Service Letter SL 36	DOA - No. EASA.21J.020
--	---------------------------------	---------------------------

Rework of Hub Inserts to Newest Technical Standard during next Overhaul and / or Repair

Applicable Drawings:

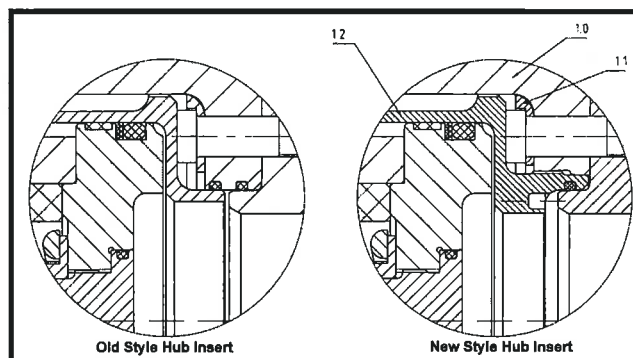
- ✓ Rework Hub 1.0 according to applicable drawing
- ✓ Rework Ring 1.1 according to applicable drawing
- ✓ New Hub Insert + Guide Ring 1.2
- ✓ Tool required: T-715

MTV-16-1-N-C-F-R(P)	MTV-27-1-N-C-F-R(P)	MTV-27-2-N-C-F-R(P)
Hub:	A-1490-1-C	A-1646-B	A-1533-C-R/L
Ring:	A-1491-A	A-1491-A	A-1491-A
New Hub Insert:	A-1488-C	A-1488-3-B	A-1488-1-A
Guide Ring:	C-276-435	C-276-445	C-276-445
